Addendum 1 for RFB927940-04

Project Name: WRC Decentralization Phase 4 & Fire Alarm Phase 3 (9279.40 & 9279.41) Bid Issuance #4
DAS RFB #: 927940-04
DAS Project #: 9279.40 & 9279.41
Date: 5/21/2026

CHANGES TO DRAWINGS

C4 ERV CONTROL SEQUENCE
NOT TO SCALE

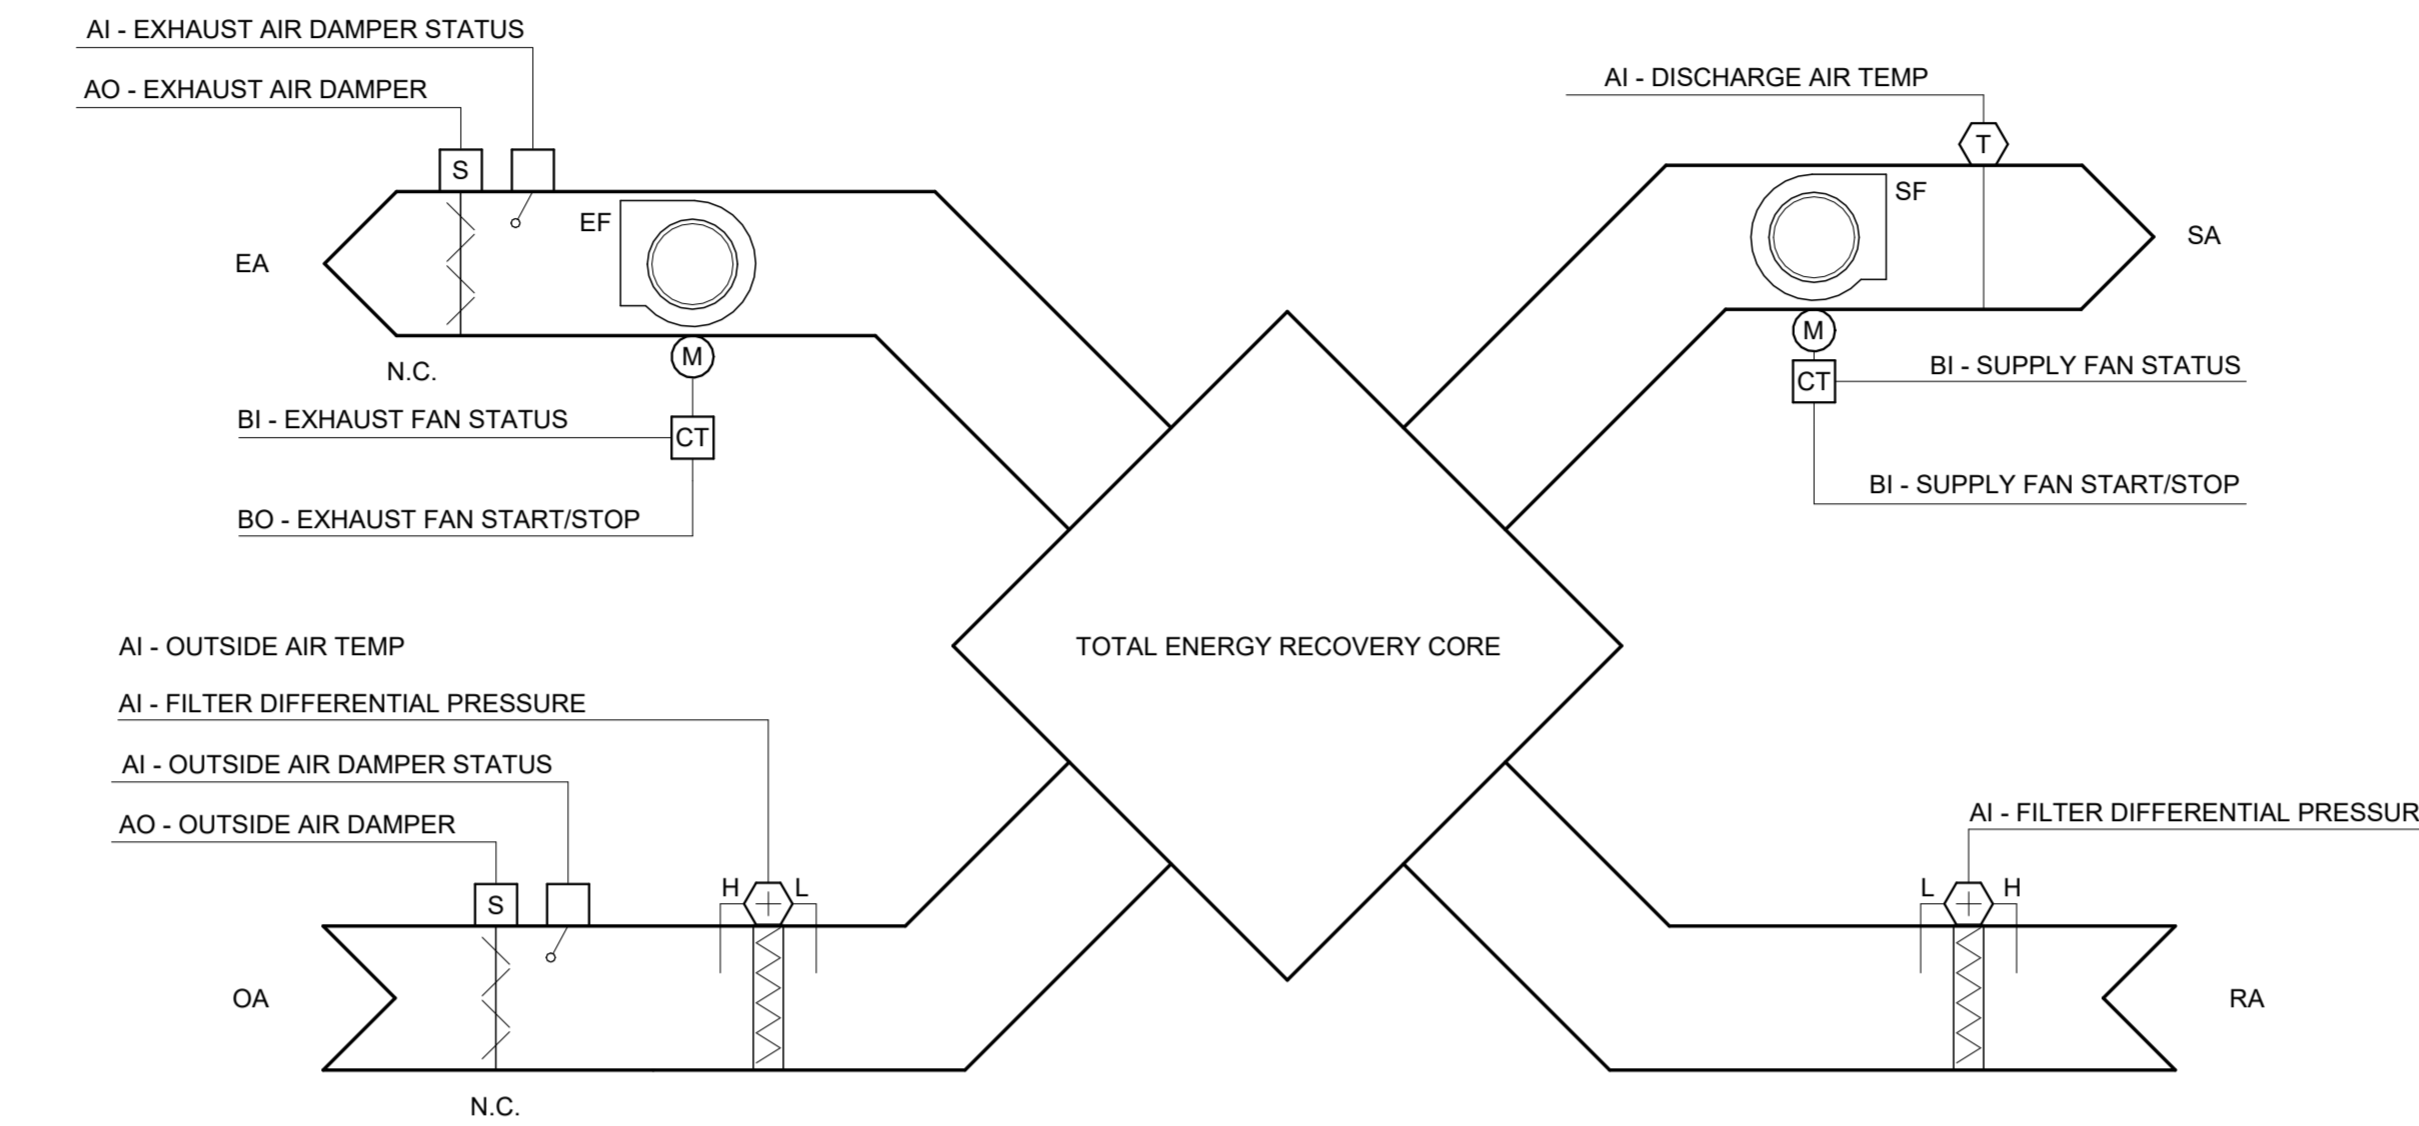
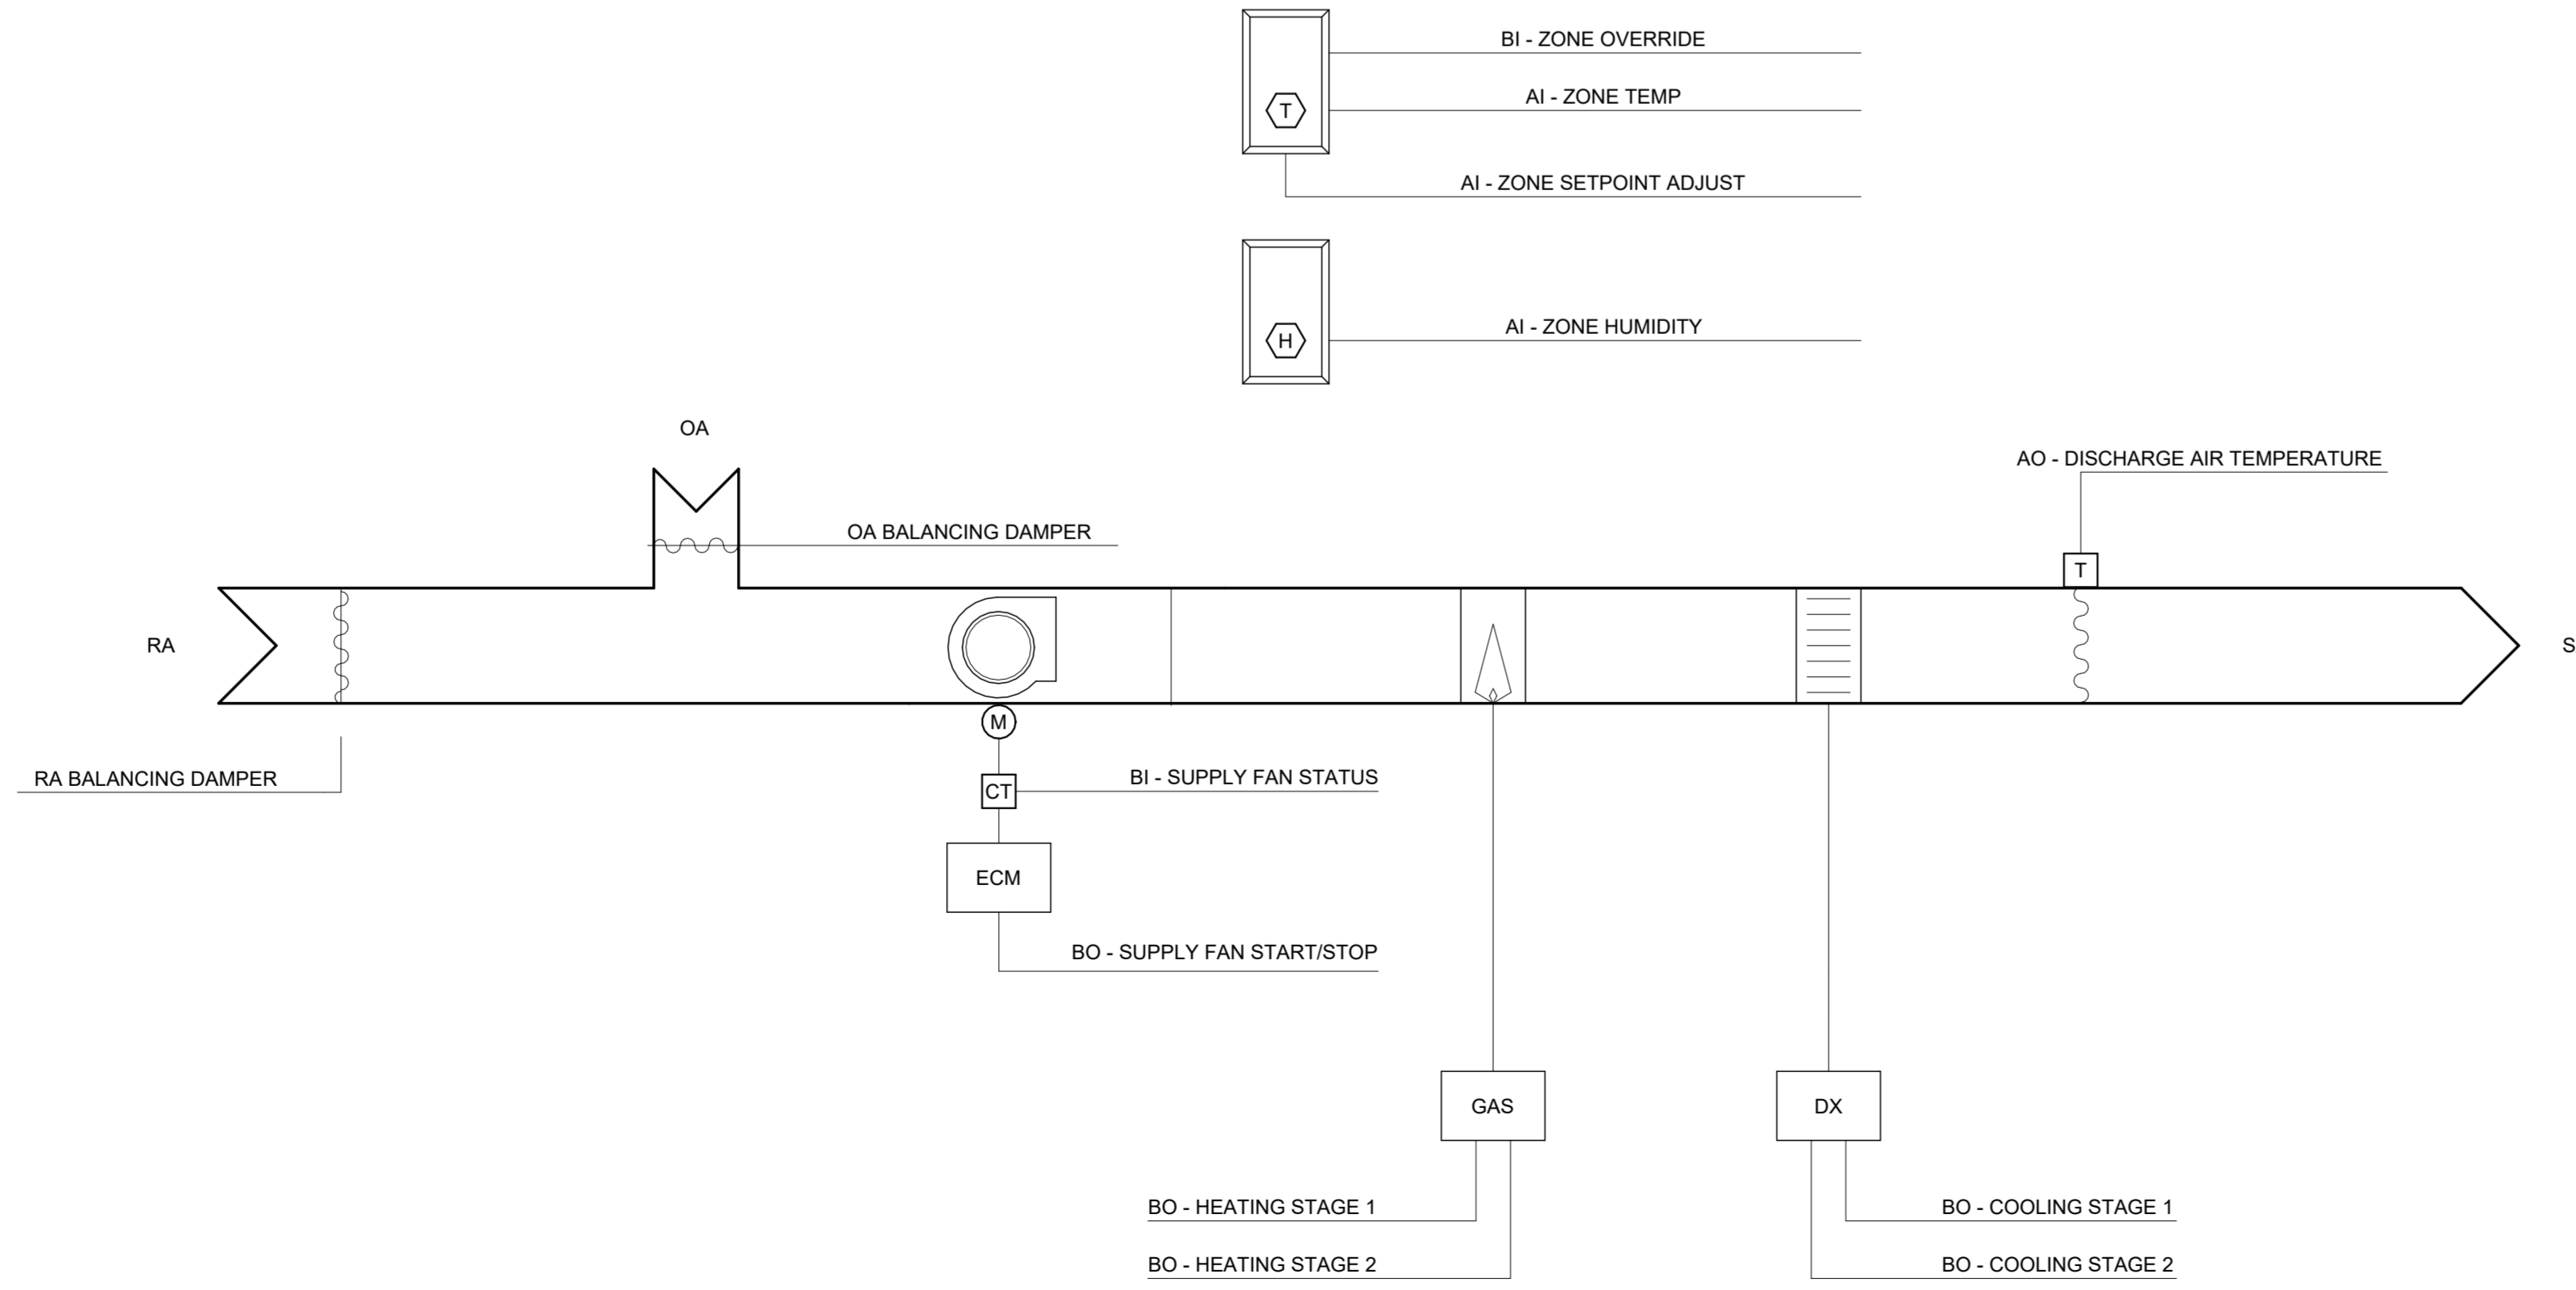
- **09-M300 – THERMOSTAT PLAN:**
 - **REVISE** thermostats in Area B Basement.
- **09-M501 –MECHANICAL CONTROLS:**
 - **ADD** ERV control sequence.
 - **ADD** heat pump control sequence.

13-MD200

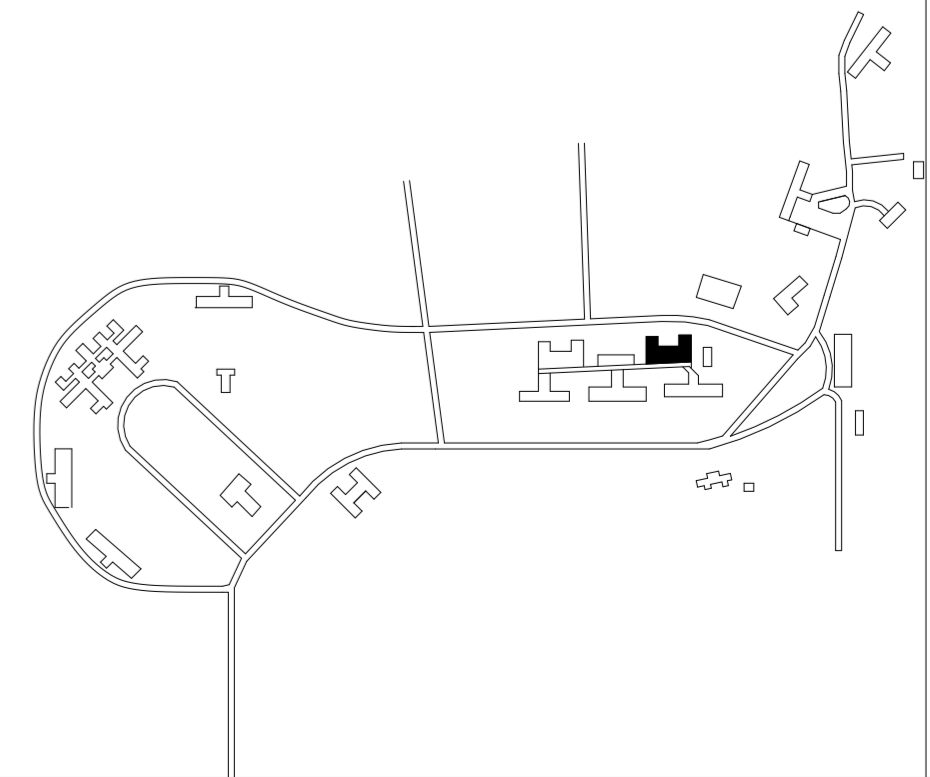
- **13-MD200 – BASEMENT MECHANICAL DUCTWORK DEMOLITION PLAN:**
 - **REVISE** extent of ductwork demolition.
- **13-MD201 – FIRST FLOOR MECHANICAL DUCTWORK DEMOLITION PLAN:**

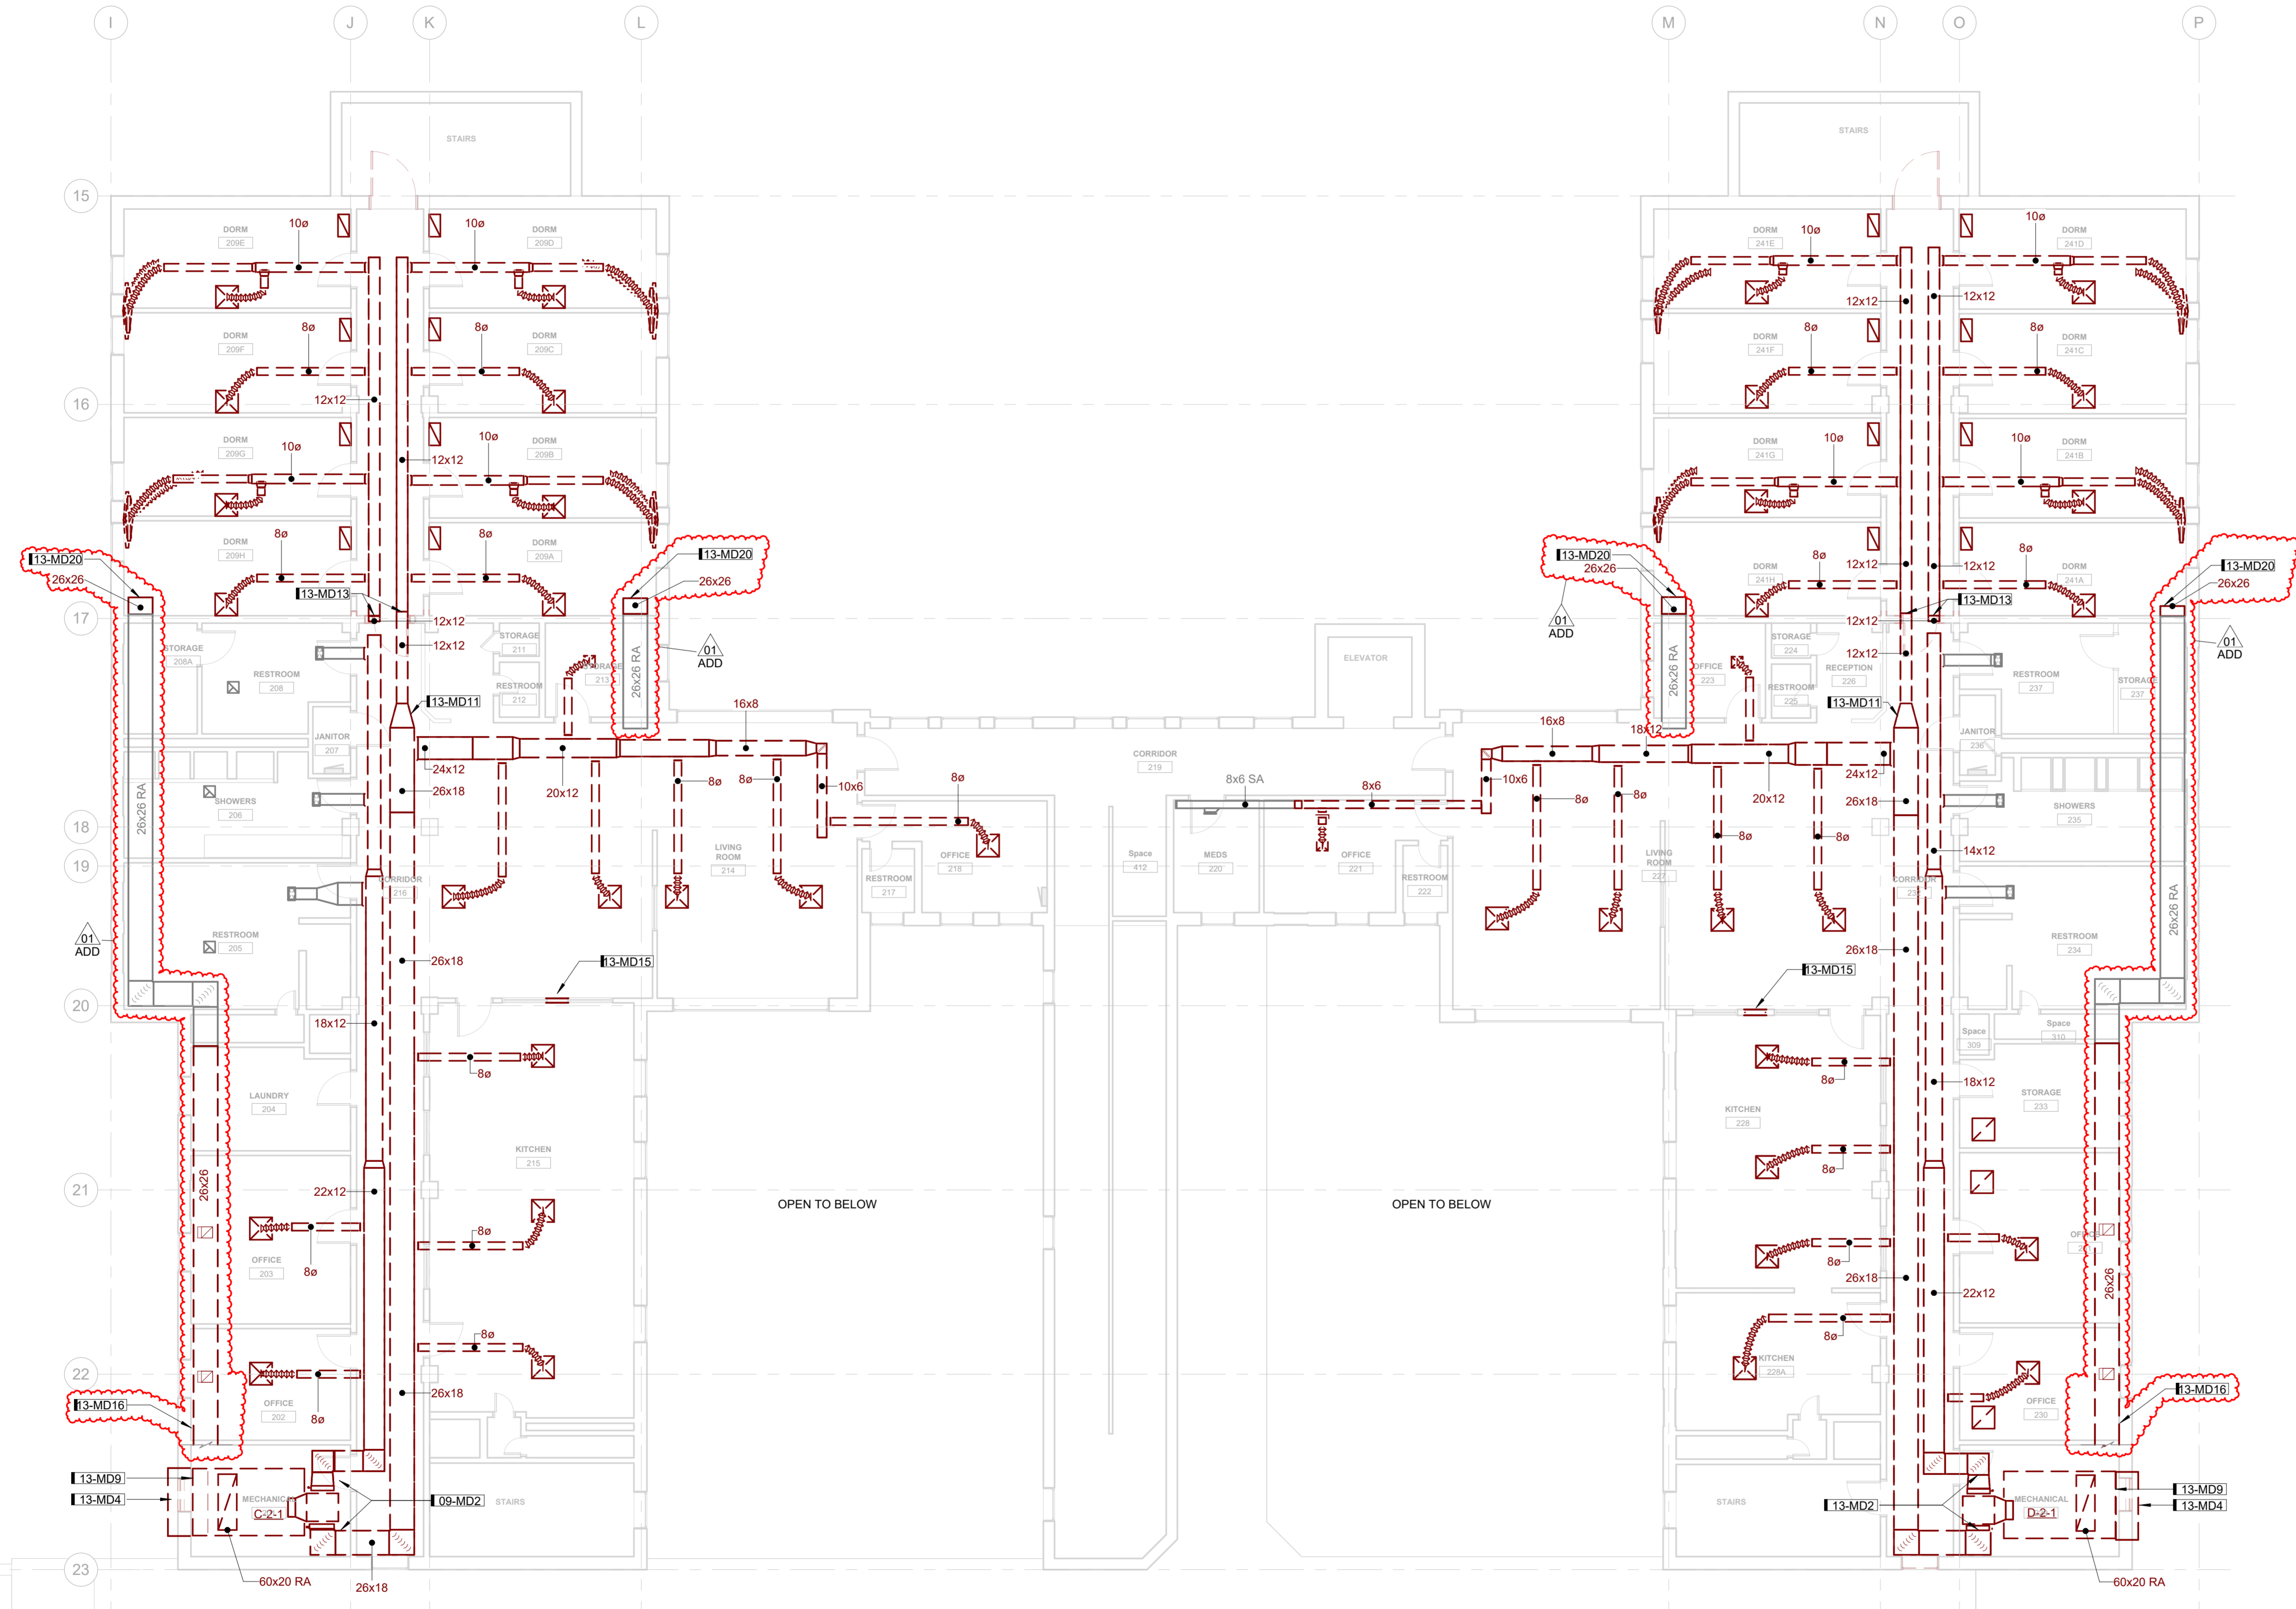
- **ADD** existing return transfer ducts and associated demolition.
 - **REVISE** keynote 13-MD16
 - **ADD** keynote 13-MD20
- **13-MD202 – SECOND FLOOR MECHANICAL DUCTWORK DEMOLITION PLAN:**

13-MD20	DEMOLISH PORTION OF EXISTING RETURN DUCT AS INDICATED BACK TO WALL AND PREPARE DUCT FOR NEW CONNECTION. VERIFY TERMINATION POINT AND NOTIFY ENGINEER IF TERMINATION POINT DIFFERS FROM ANTICIPATED LOCATION.
